Amendments to the Drawings:

REMARKS

LUMINAIRE
INVENTOR: BARRY WHITE, et al.
SN: 10/616,743; DOCKET NO.: 0331
ATTY: DONALD E. HASSE; PHONE: (513) 229-0383

FIG. 1

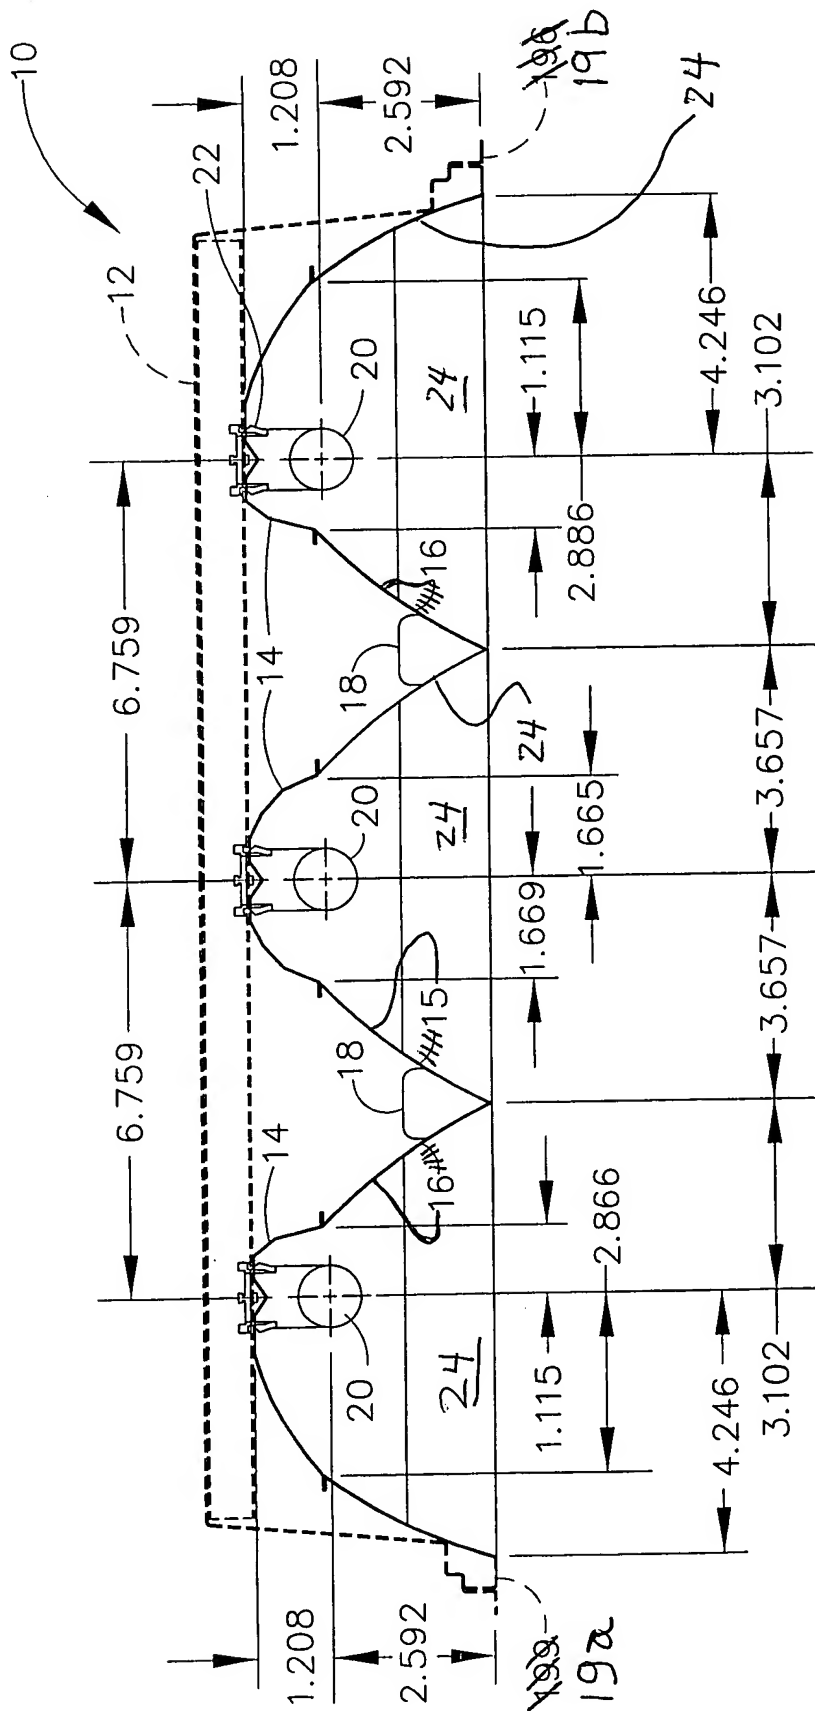
In the drawings, the Examiner has objected to the references 19a and 19b as designating both "edge" and "outer edge" (at page 5, lines 12 and 23). To traverse this objection, Applicants have amended the specification at paragraph [0020] to change "edge" to "outer edge".

Applicants are submitting replacement drawing sheets 1 and 5. Drawing sheet 1 for Figure 1 has been amended to correct the reference number "199" to --19a-- and "196" to --19b--.

Support for these amendments is found at page 5, lines 12 and 23 of the specification as filed. Figure 1 has also been amended to adjust the lead lines for reflectors 15 and 16, and to add reference number 24 with lead lines to the louvers. Support is found in FIG. 5 and in Claim 14 as originally filed.

FIG. 5

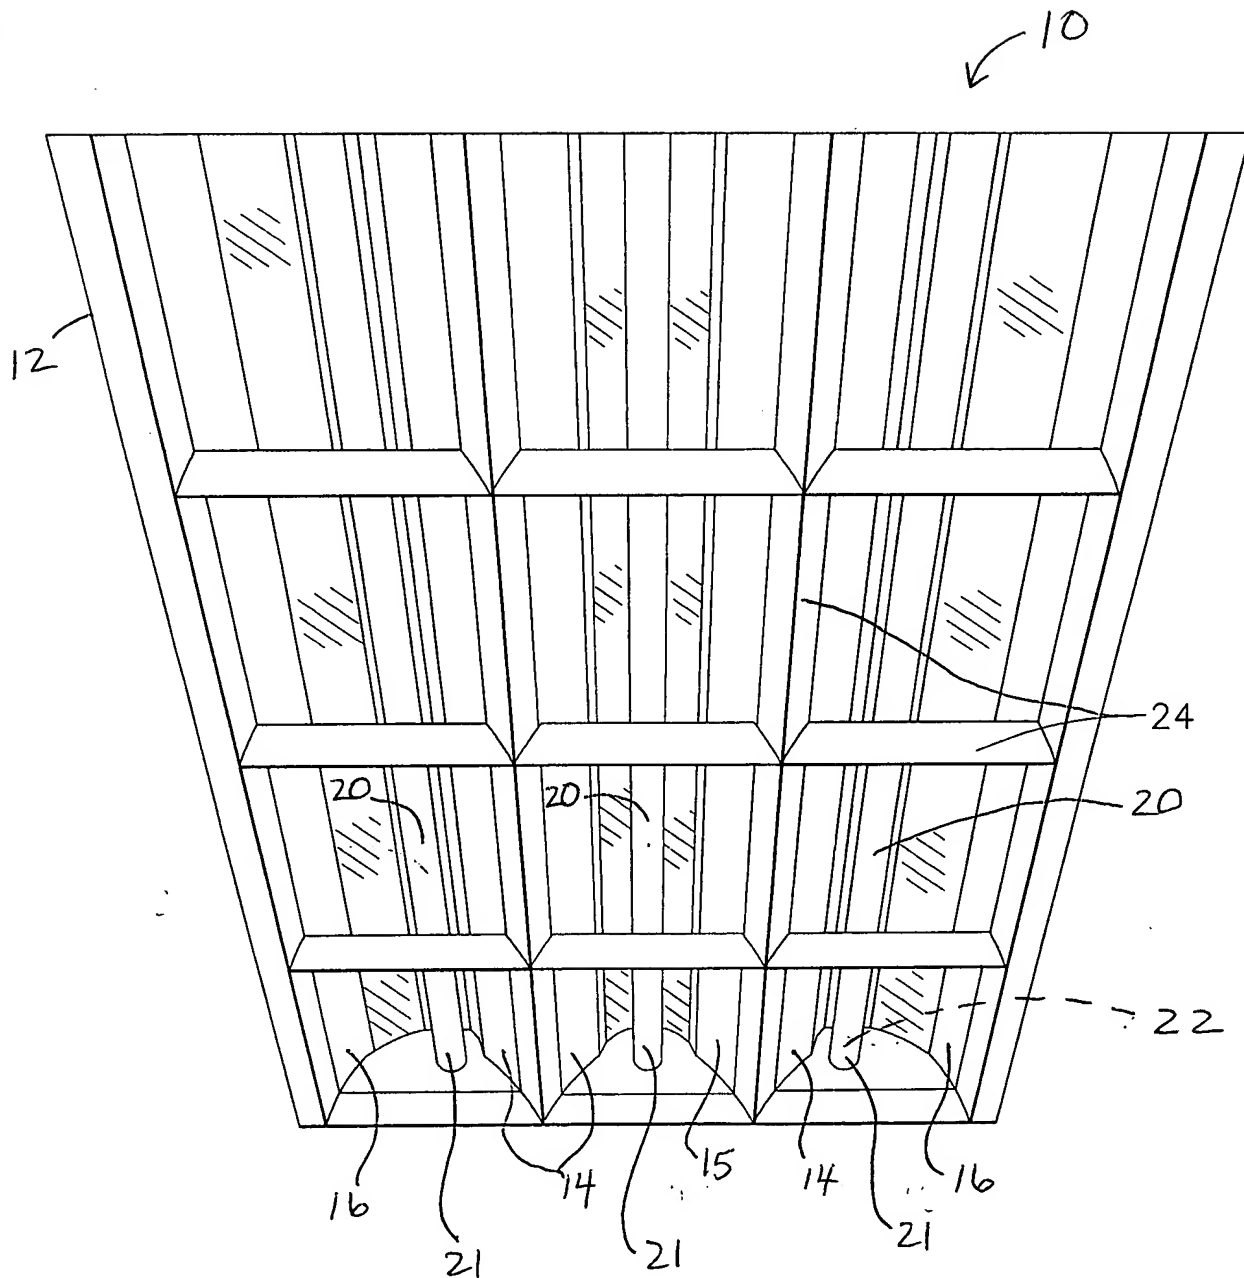
Drawing sheet 5 for FIG. 5 has added reference numbers and lead lines for the following elements: luminaire 10, housing 12, reflector 14, symmetric reflector 15, asymmetric reflector 16, tube 20, tube ends 21, tube end 21, and socket 22, and an additional lead line from reference number 24. Support can be found in Figure 1, and Claim 5 as originally filed.
